WATERSTONE, Fil. No. 4-Site Plan

Technical Correction-Response to Comments

Re: Waterstone Filing No. 4
Site Plan Comments and Technical Corrections
Aurora, Colorado

05 OF 37

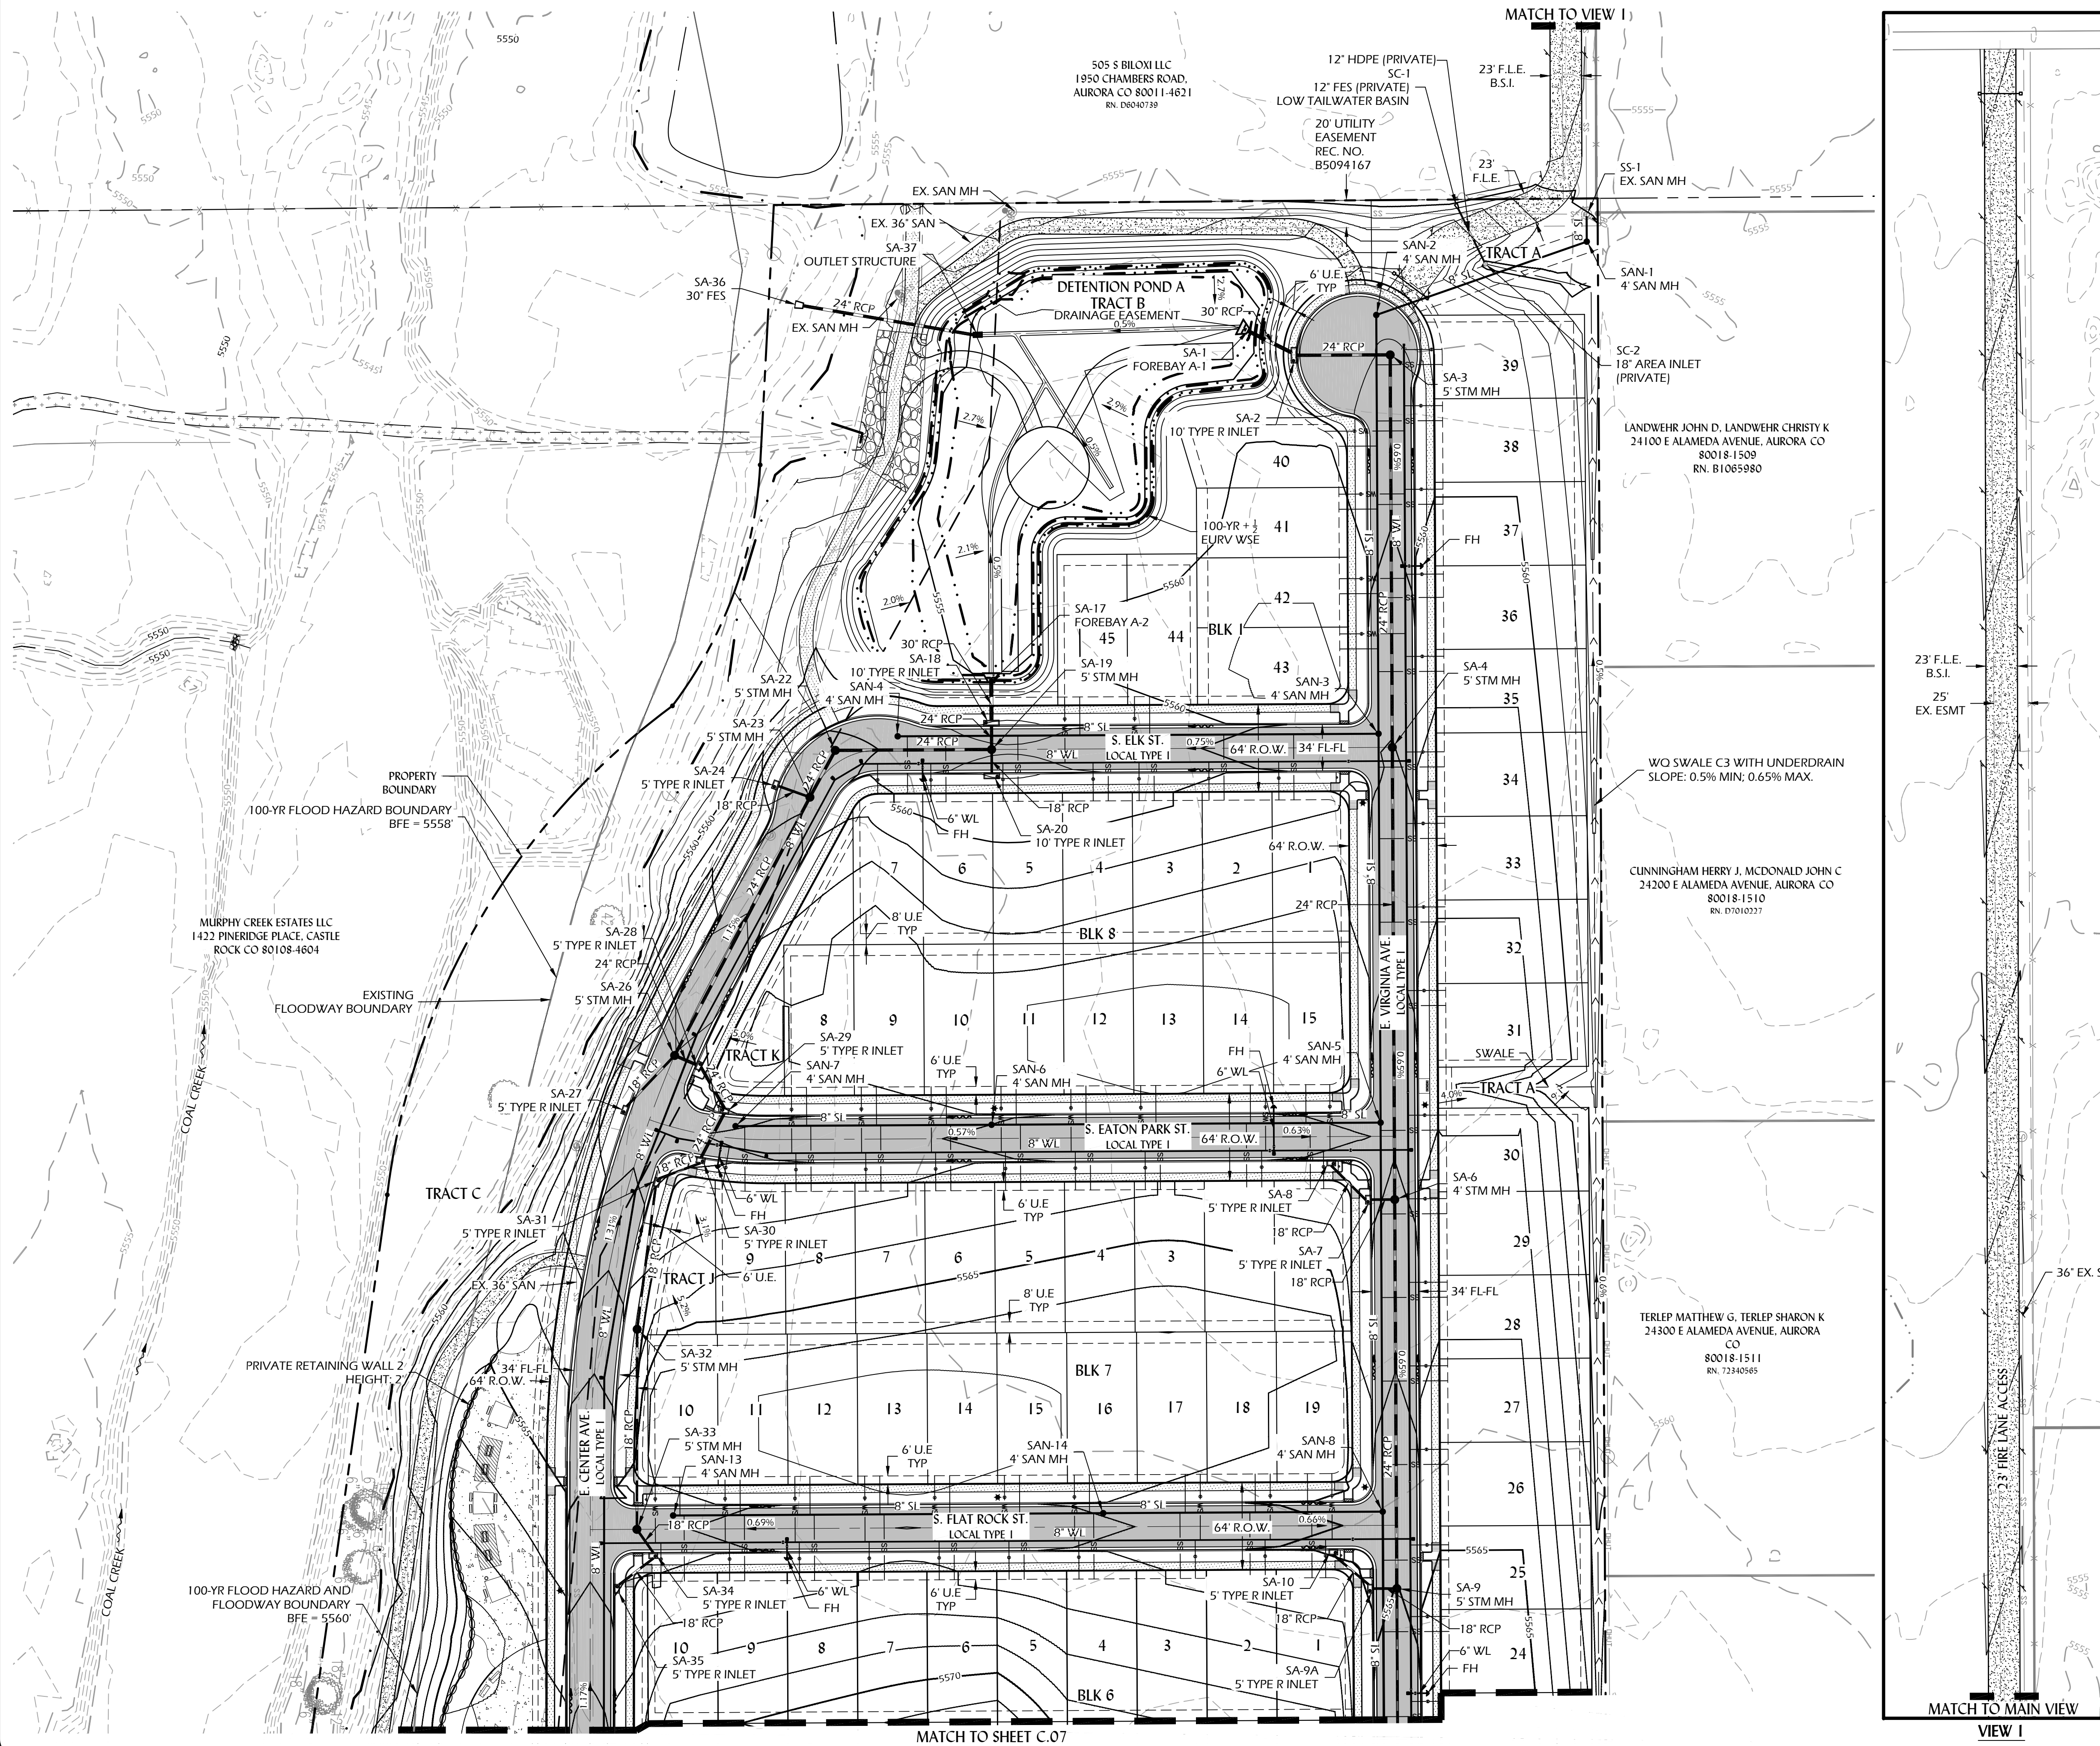
Add a note indicating if the storm sewer system is public or private and who will maintain it.

Note that identifies storm sewer ownership has been added.

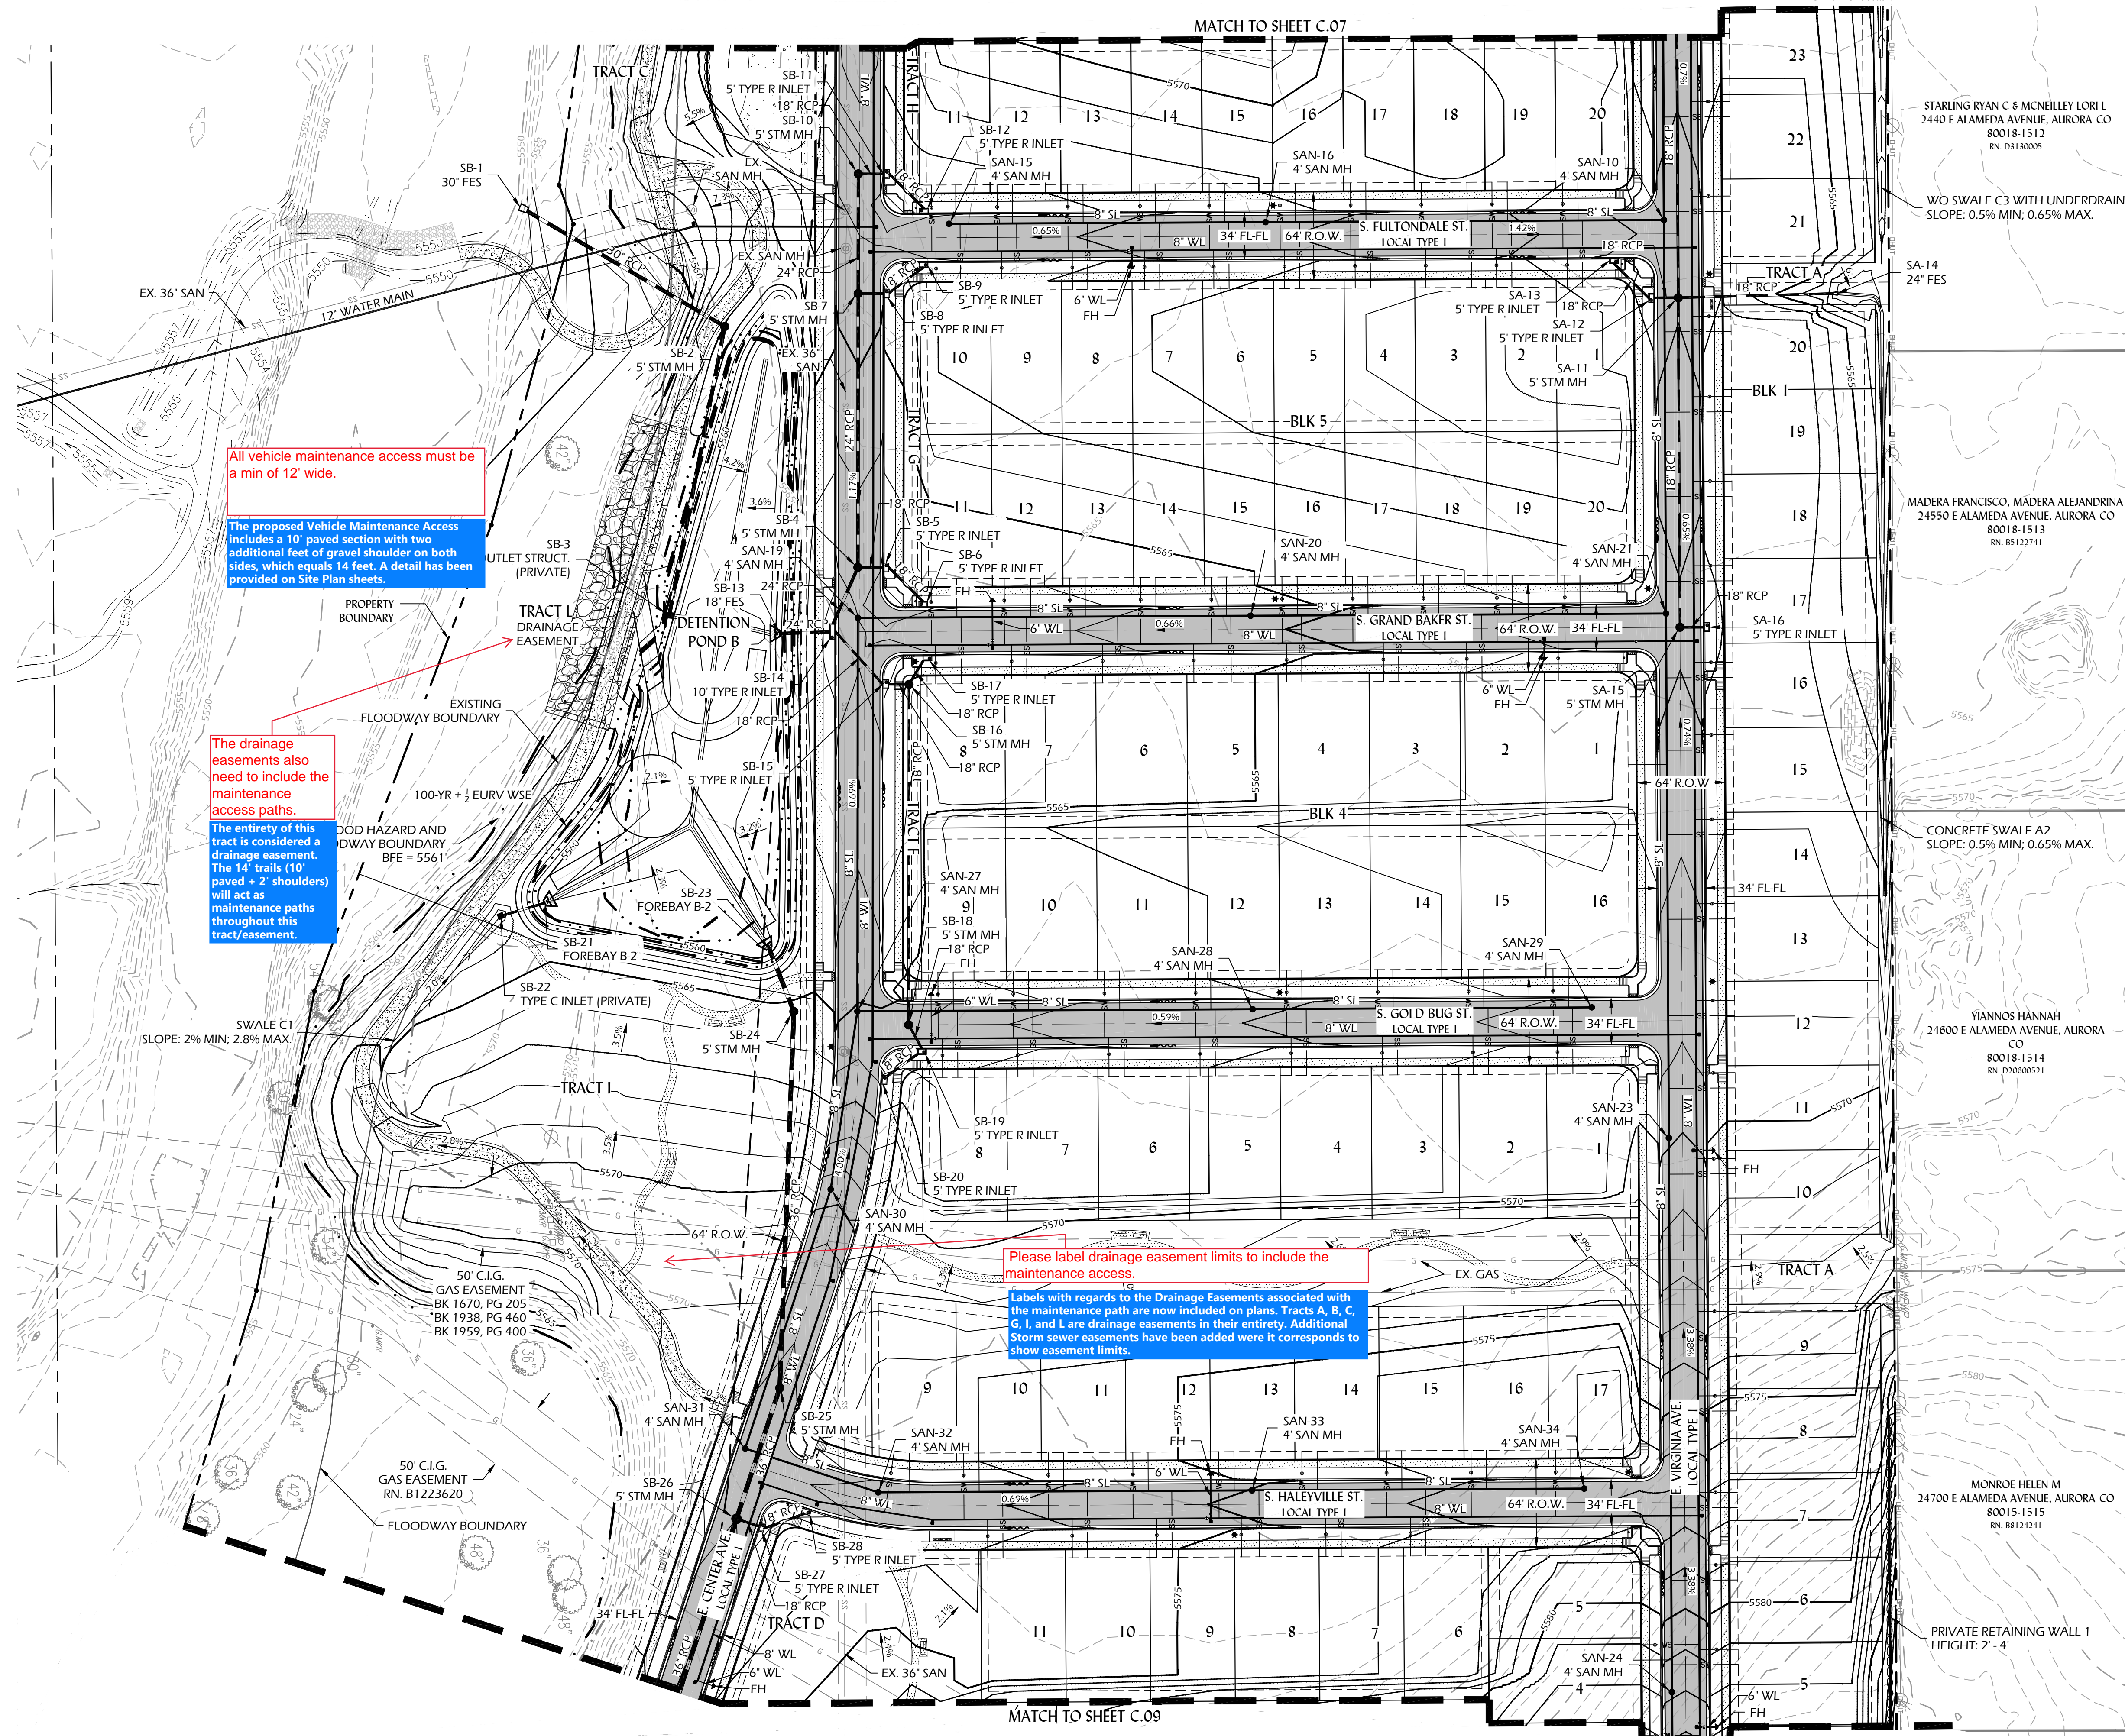
Add a note indicating if the storm sewer system is public or private and who will maintain it.

Note that identifies storm sewer ownership has been added.

C.09

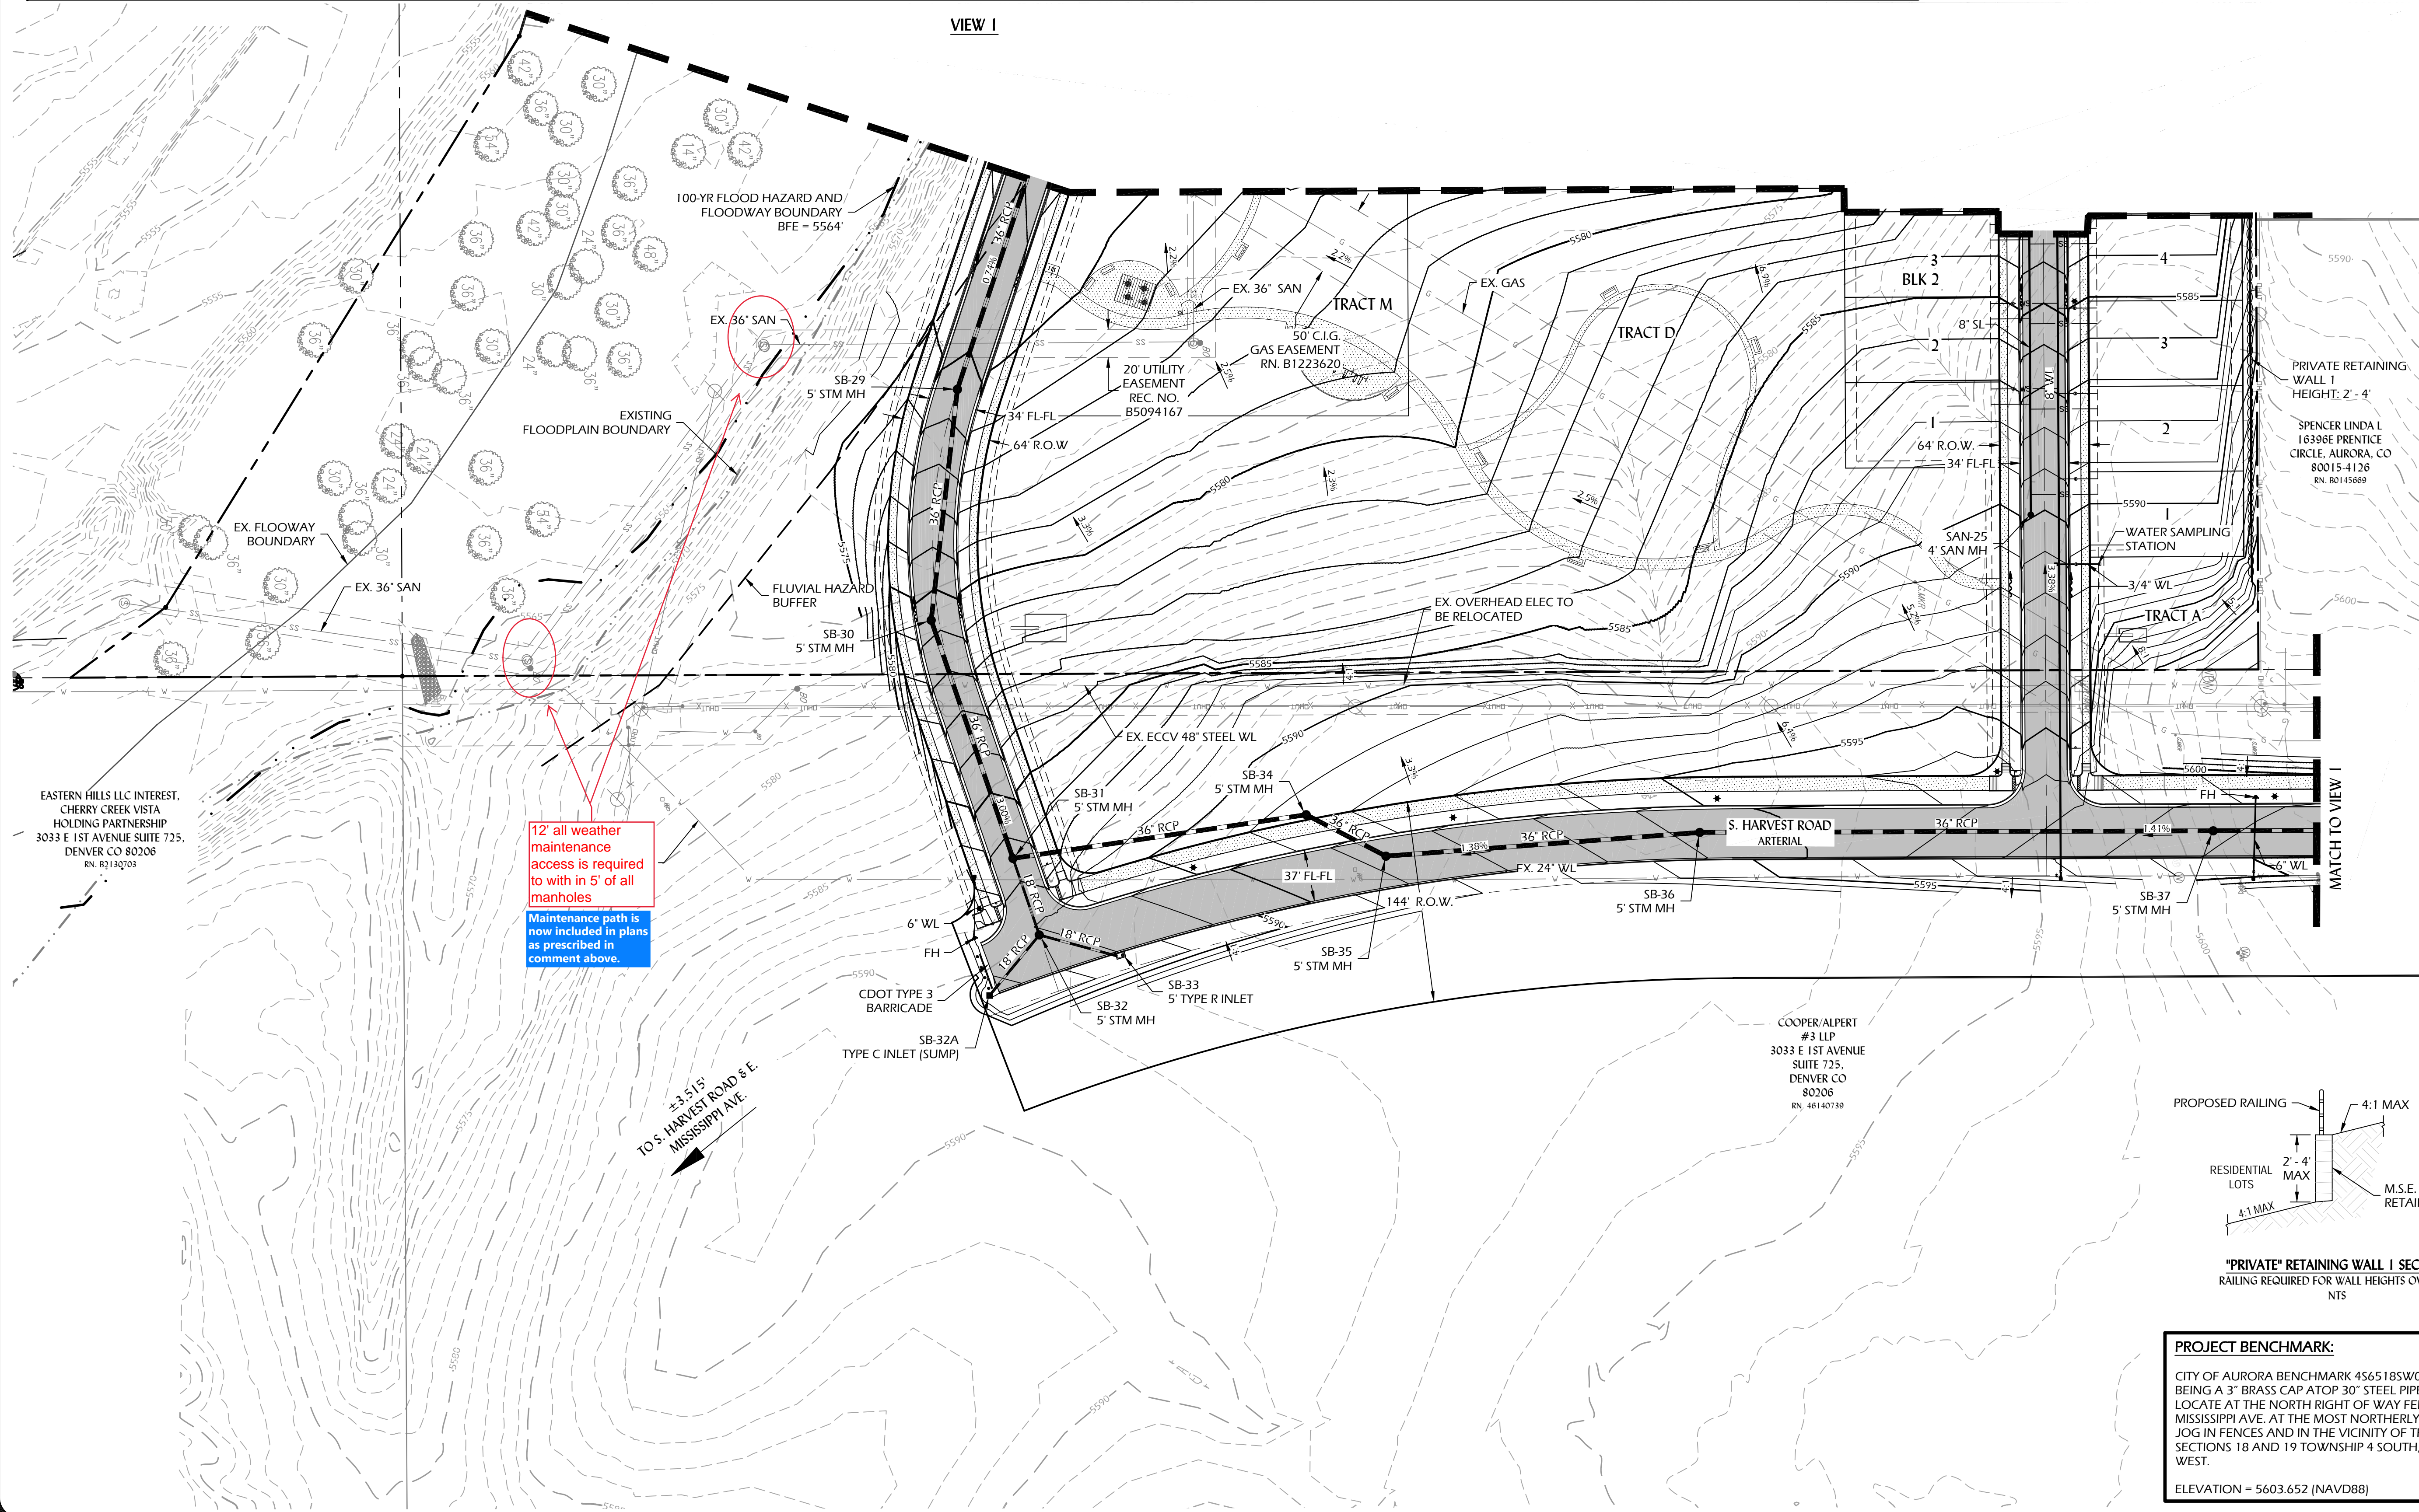
Add a note indicating if the storm sewer system is public or private and who will maintain it.

Note that identifies storm sewer ownership has been added.
